Submittal Contents:

Resident Storage Locker Submittal
154 storage lockers provided; 153 lockers shown in plan.

WESLEY HOMES

A1.1B-FIRST FLOOR PLAN EAST

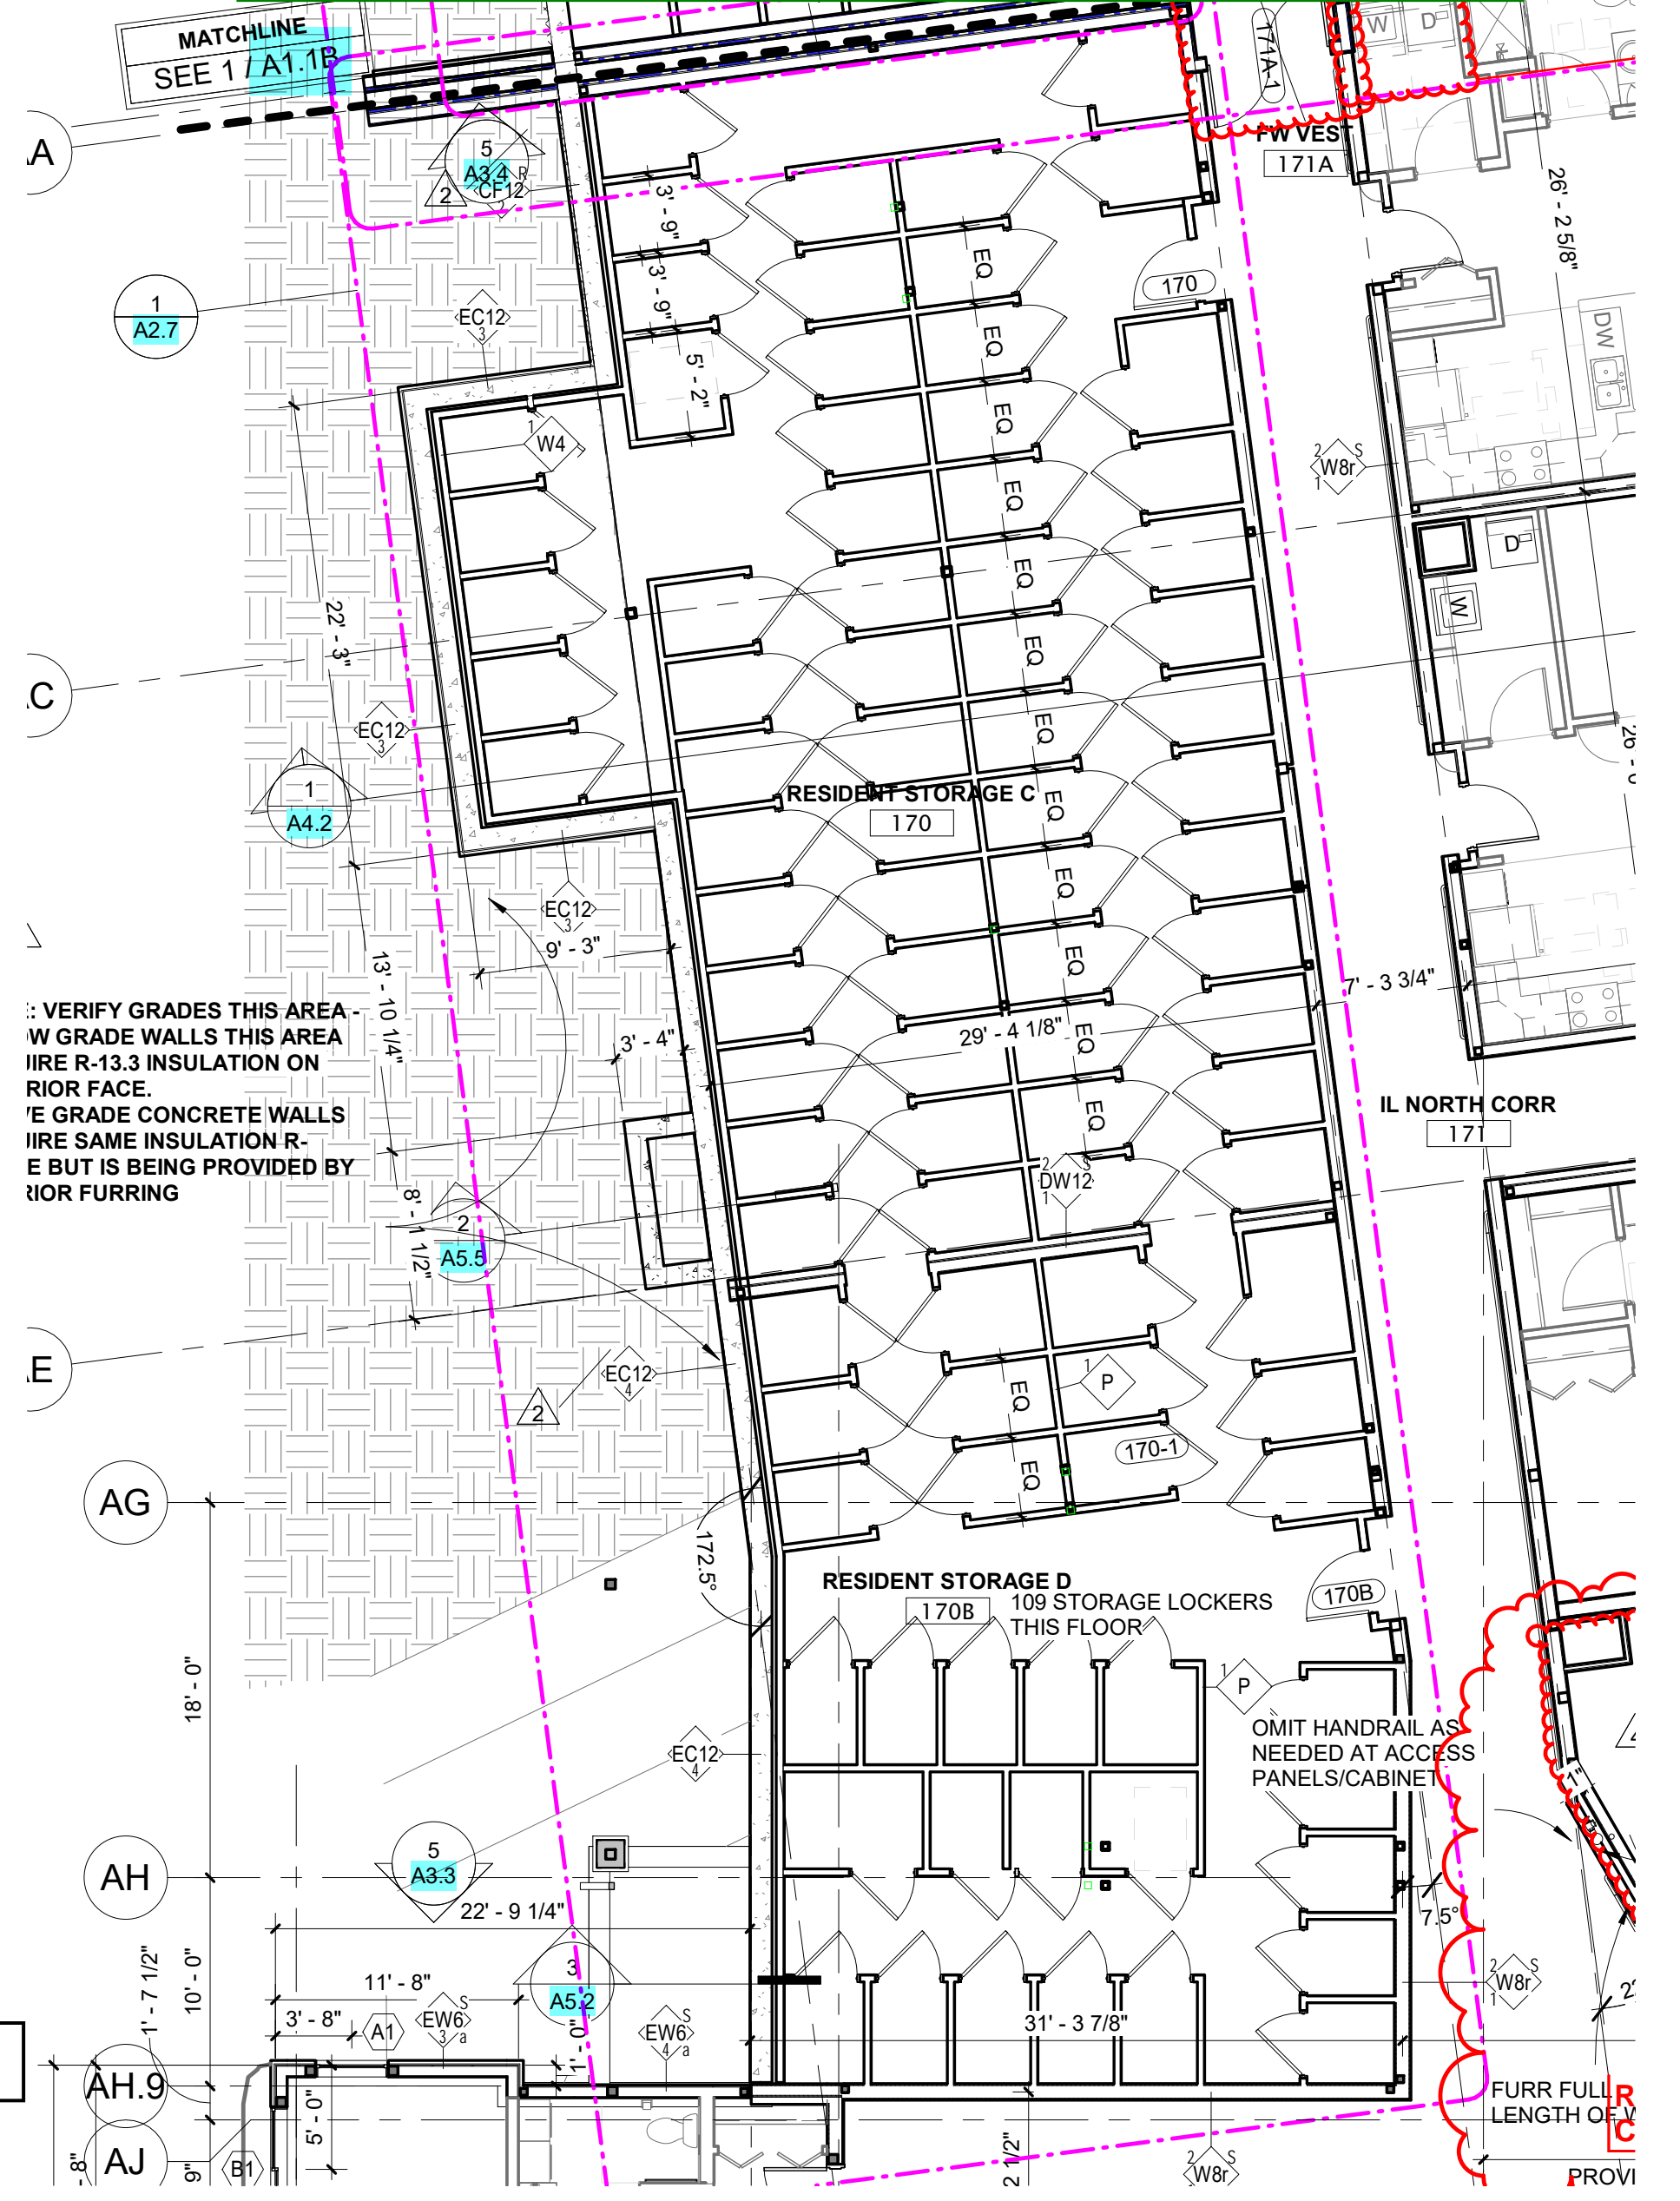
Numbers to be placed on the top frame of the lockers above the door. Please confirm requested number sequence.
